### **Draft Marryatville Precinct Master Plan**

This is a joint submission from Bike Adelaide (just under 2,000 members) and Norwood Payneham & St Peters Bicycle Users Group (NPSP BUG – with some 160 members).

### Marryatville Precinct 2 of 3

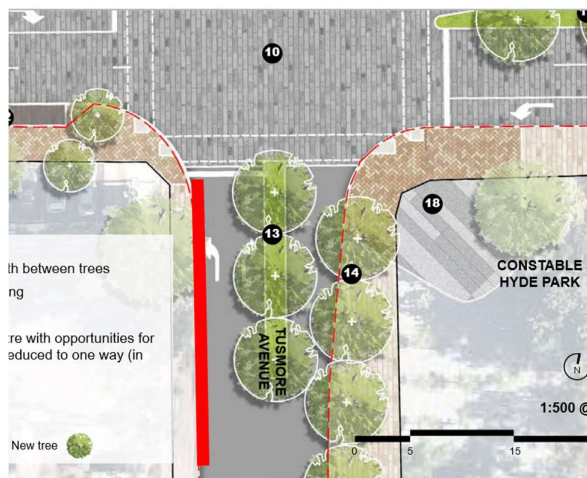
1. While we support wider footpaths, in this area they are stated as being up to 1.5m extra in an area where existing businesses would generally not use this. Here, dedicated road space would improve cyclist safety, particularly when traffic is stopped due to traffic signals but cyclists could be allowed to move during the pedestrian phase. Footpaths are not necessarily the only source of space that could be allocated to cyclists: the proposed lane widths are not stated. Narrow lanes would reinforce the different character of the Precinct and could release road width for cyclists.

2. Uxbridge Road should be provided with a "bicycles excepted" subplate to the one-way restriction. Cyclists are likely to use the road to reach the pedestrian crosswalk; it is advisable to design accordingly.

3. A bike parking node should be provided at Uxbridge Road.
4. We do not support integrating two car parking spaces on the south side of Kensington Road. The benefit of this small amount of parking provided just outside of an off-street car park is debatable, but it would definitely create a car door hazard for cyclists.

5. While the greening in Tusmore Avenue reserve is generally supported, a section of bike lane roughly as shown below is a high priority to provide a safe area for cyclists. A signal stud with bike button would enable cyclists to 'call' a pedestrian phase and travel under signal protection while cars are held, to access Uxbridge Street, Shipsters Road or a refuge turn into High Street.

6. Detailing of the car park roadway is confusing. This is a driveway and should be detailed as such, with a continuous footpath giving pedestrian priority.

7. We support extension of paving in Tusmore Avenue to provide a wider footpath, but its extension across the entire verge could be excessive. Whether this is proposed is not clear. In any case, a wide pavement would attract shared use and we suggest a ramp transition at the southern end of the footpath.
